SR 92 Widening and Reconstruction from the Northpoint Parkway to the Cherokee Trail

Value Engineering Study Report

Final Design Development

re: Project Numbers NH-165-1 (40), Widening of State Route 92 from Woodland Road to Cherokee Trail and NH-165-1 (42), State Route 92 Widening from Northpoint Parkway to Woodland Drive in Cherokee County, Georgia
Value Engineering Study Report

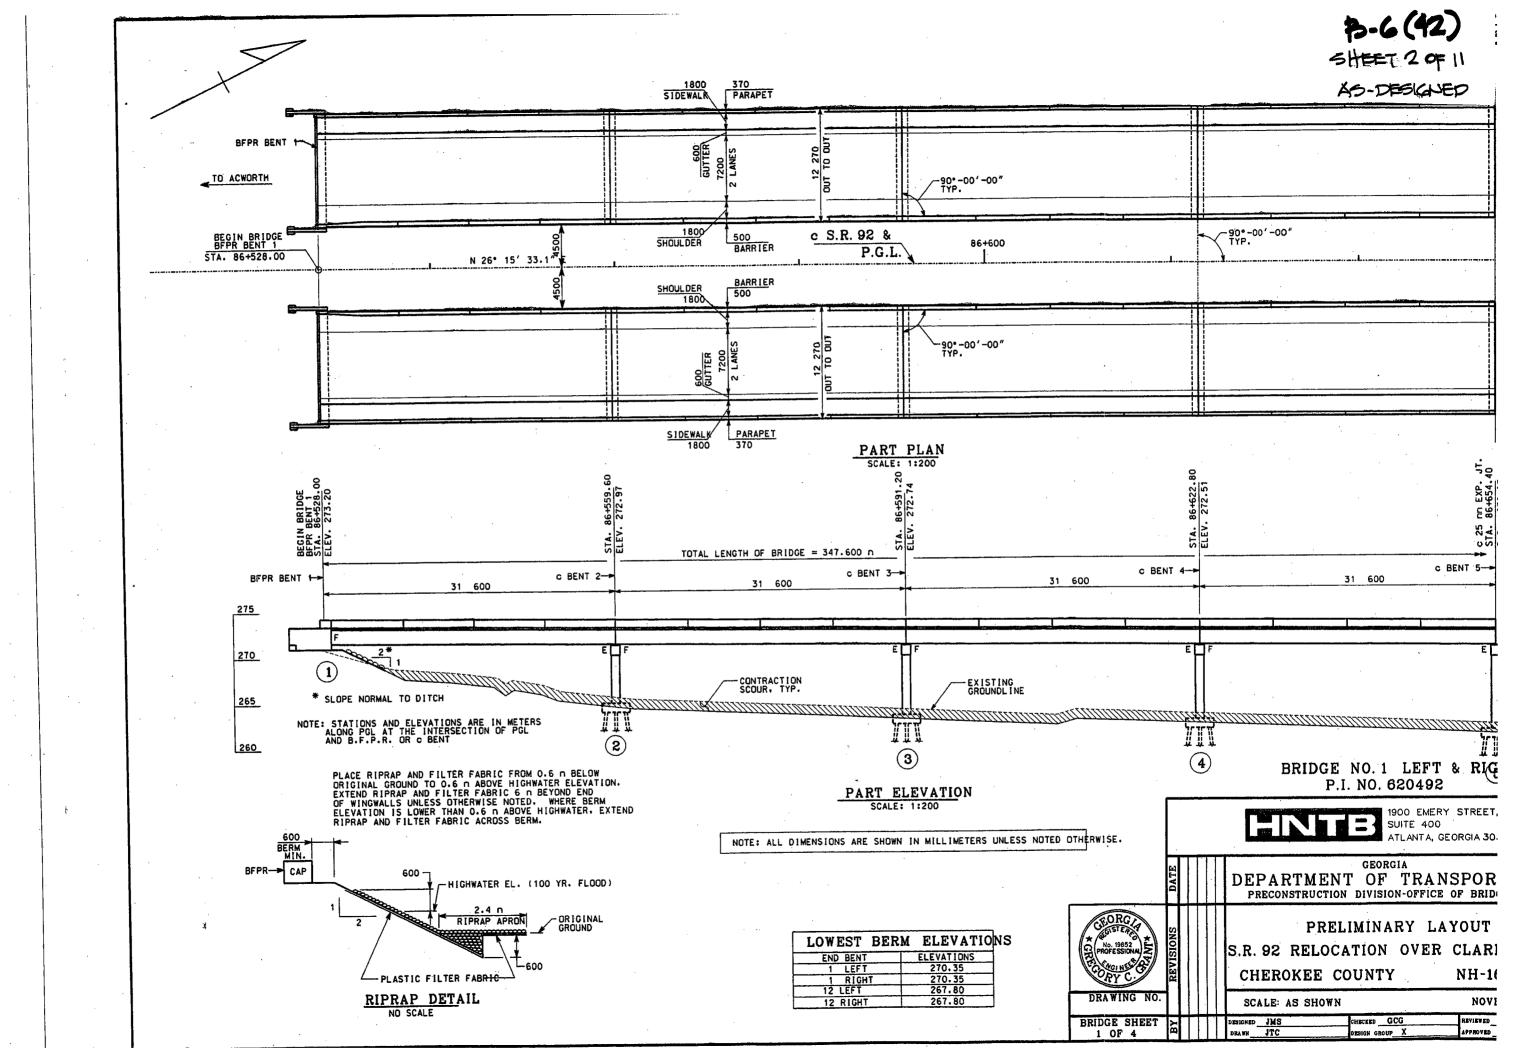
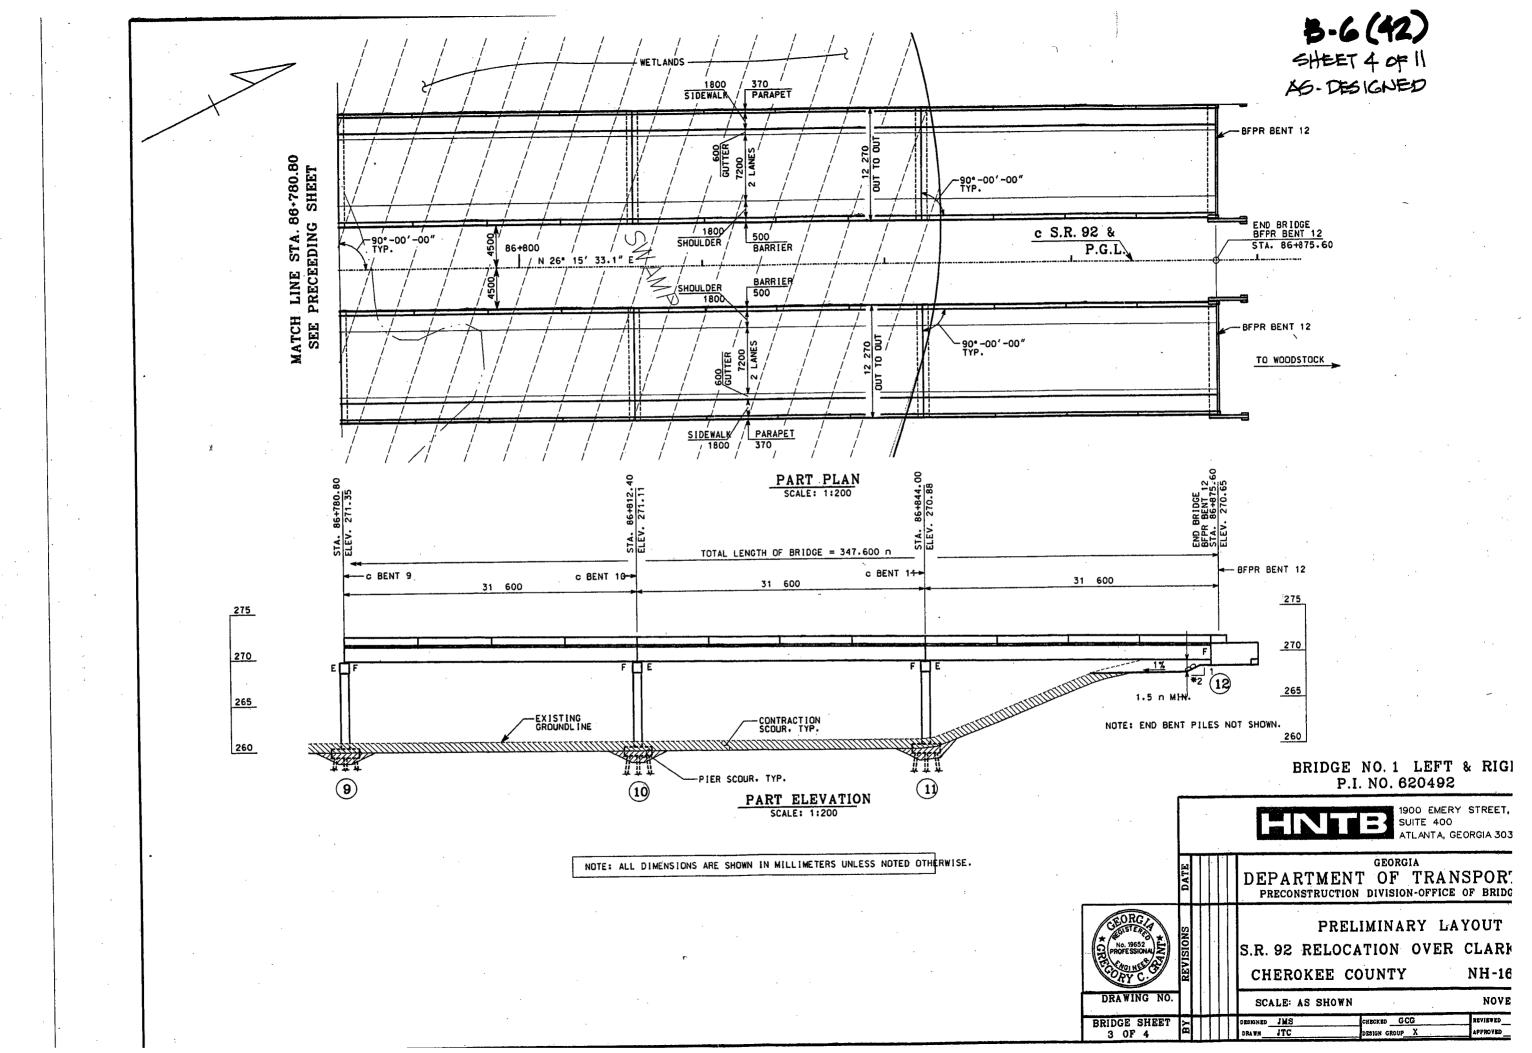
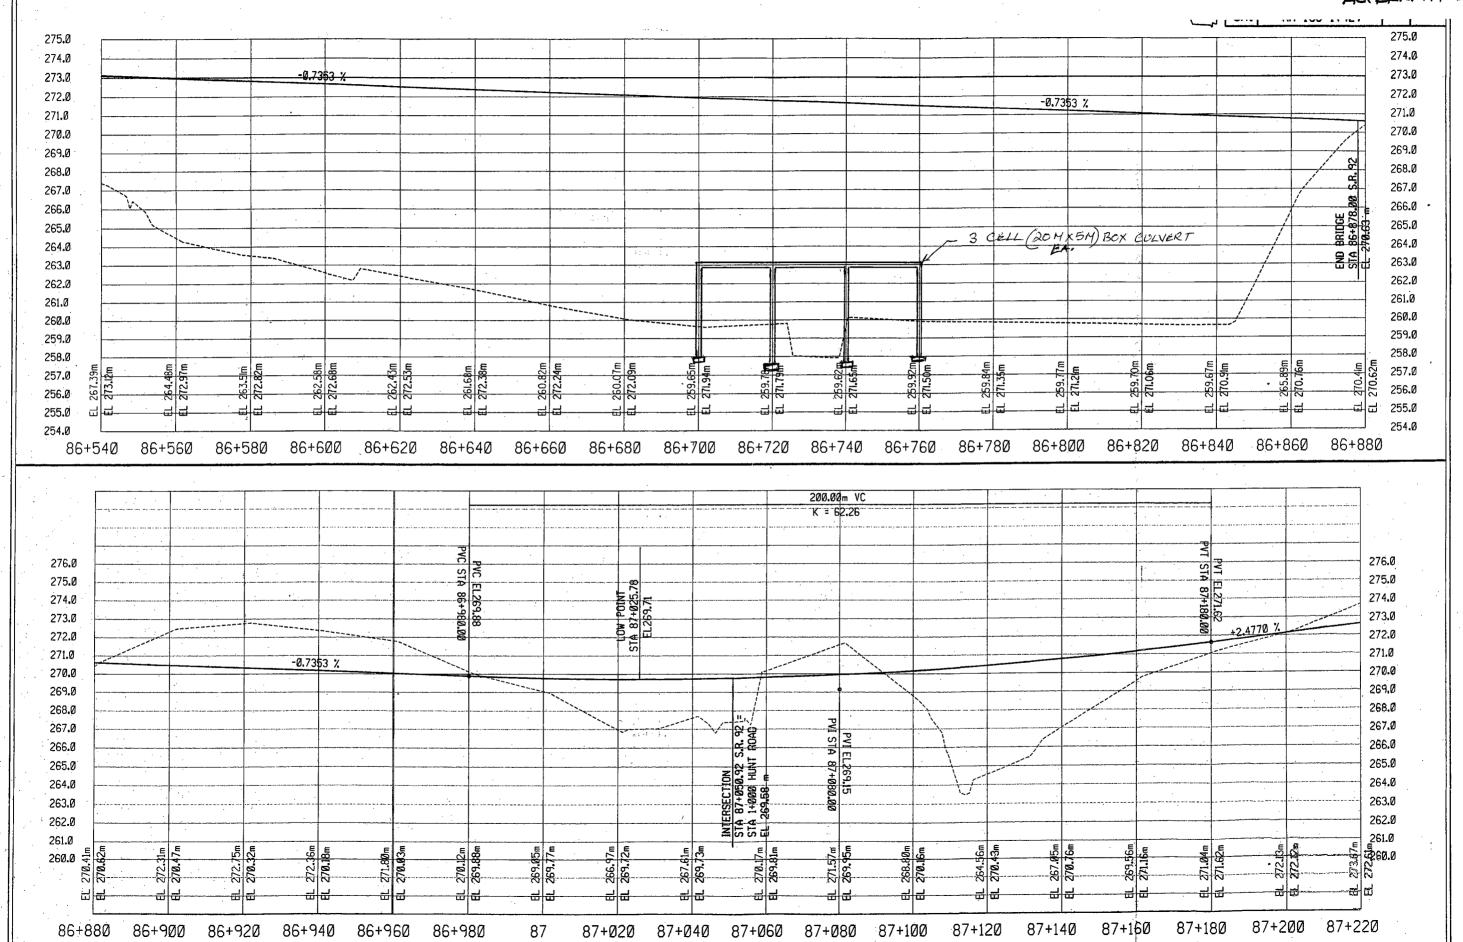
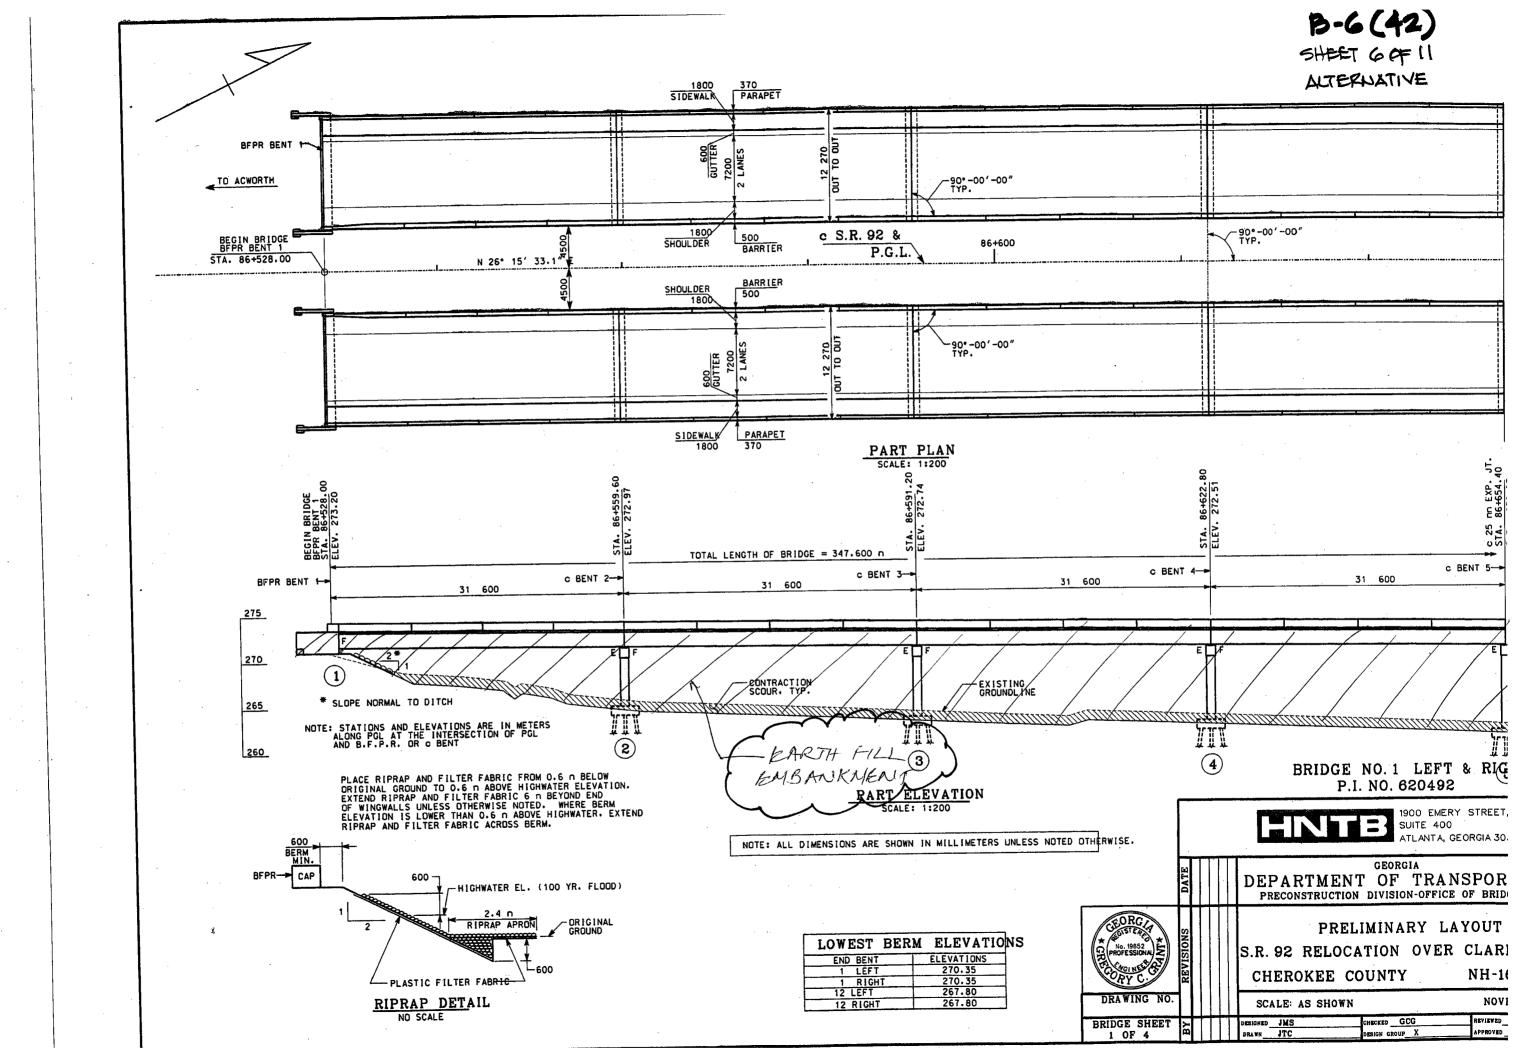
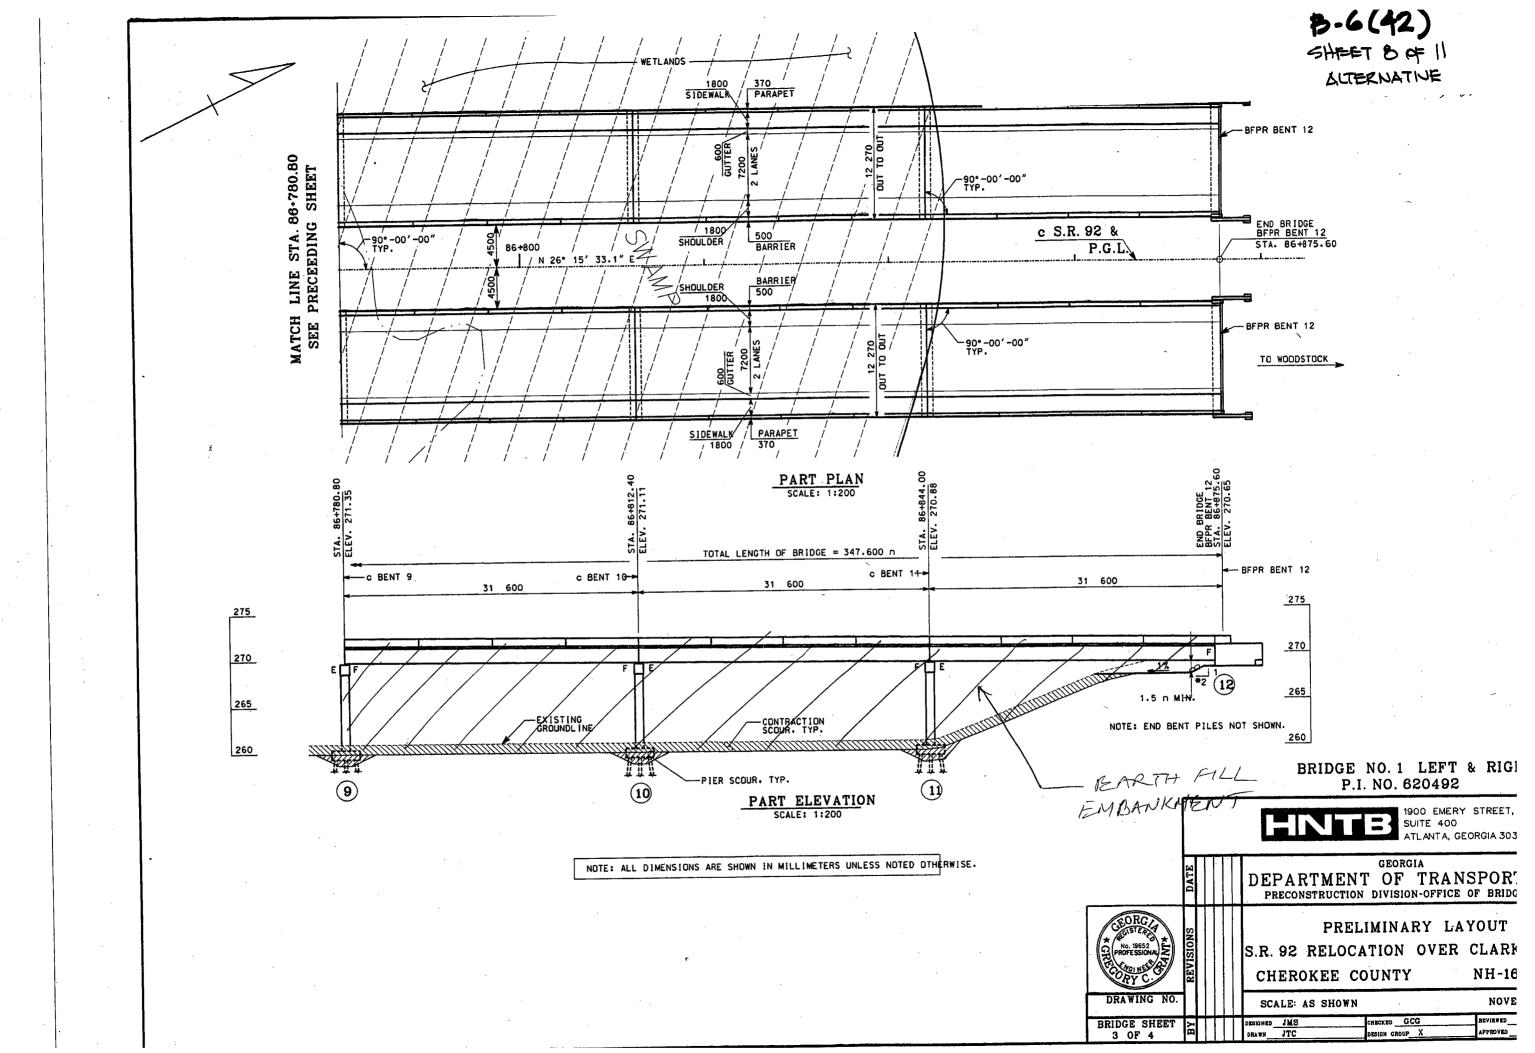
The proposed 347.600 meter (m) bridge could be shortened considerably or eliminated in its entirety by using a triple cell box culvert of 60 m x 5 m (three cells 20 m wide by 5 m high) open bottom type. Embankment and / or fill material could be borrowed from the abandoned alignment of SR 92 over Clark Creek.

Along the new alignment, provide a new culvert structure to replace the proposed twin bridges over Clark Creek and accommodate the travel four-lanes on a new embankment. Use the existing, to-be-abandoned embankment of Clark Creek as the fill material for the new embankment.

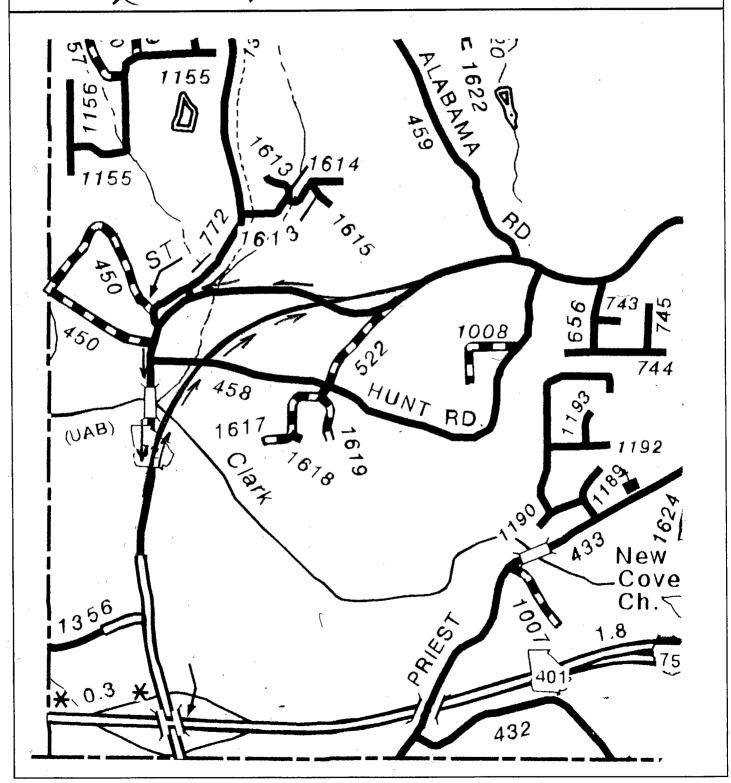
It is noted that right-of-way costs need to be checked and upgraded to match current estimate.

1.5 (AZ)

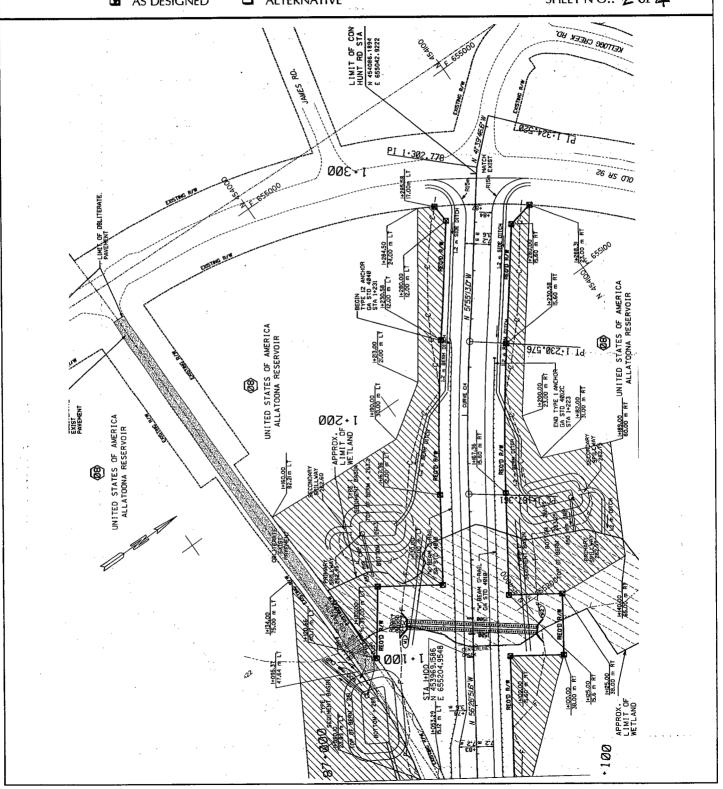
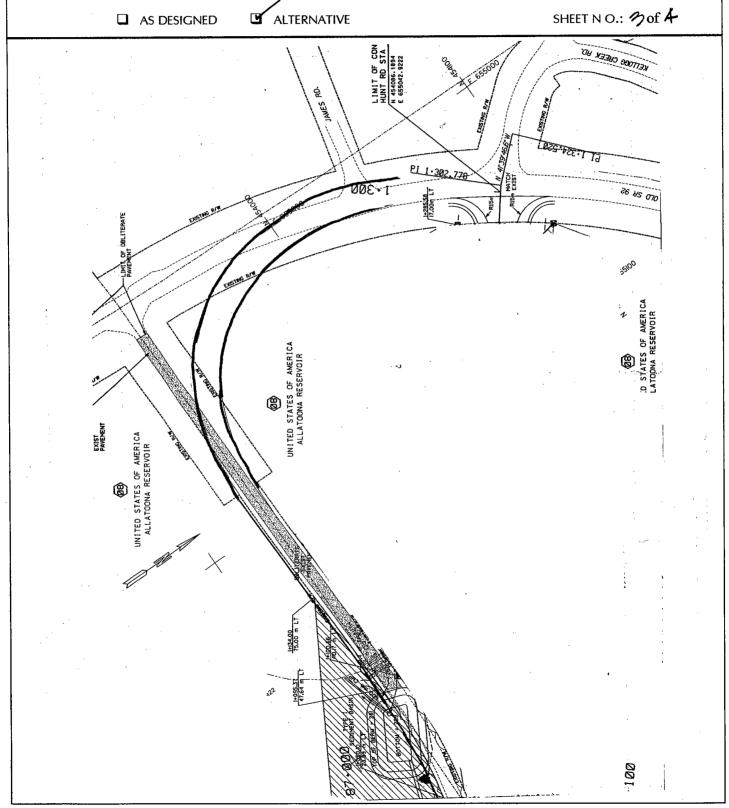
Original design relocates Hunt Road from the new location of SR-92 to the old location of SR-92. This change aligns Hunt Road with Kellogg Creek Road and requires 300 meters of new roadway, a new culvert over the northeast tributary to Clark Creek, and three settlement basins for erosion control.

Keep Hunt Road in its present location and eliminate the 300 meters of new roadway. An additional third lane should be added which will require an additional right-of-way as well as an extension of the existing culverts under Hunt Road.

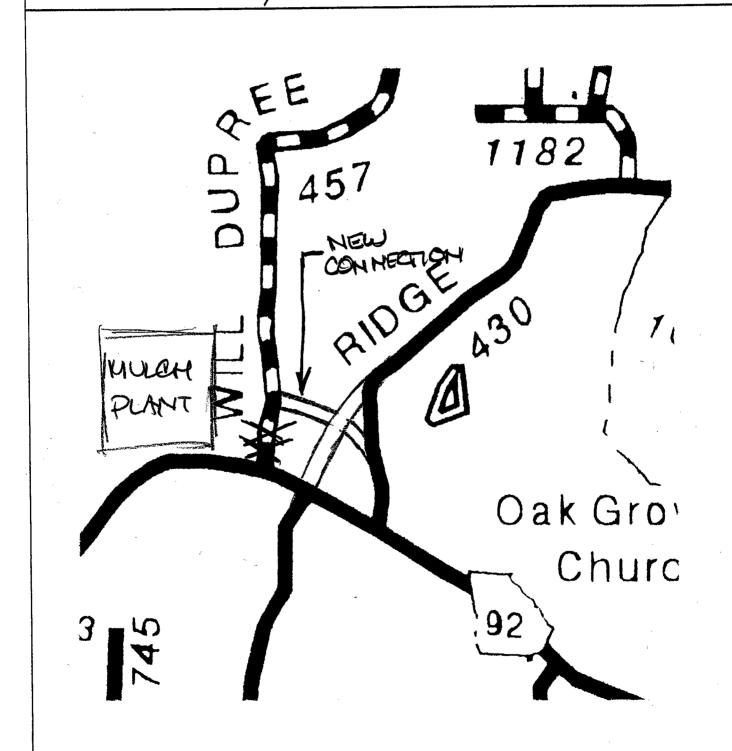
While acknowledging a cost increase to the project, this alternative provides a much safer, more convenient alignment for the trucking operation associated with the mulching plant. Rather than providing an additional median break on SR 92 where numerous openings are already planned, reroute the traffic to the relocated Little Ridge Road alignment where the truck traffic can then use the new proposed intersection of Little Ridge Road and SR 92.
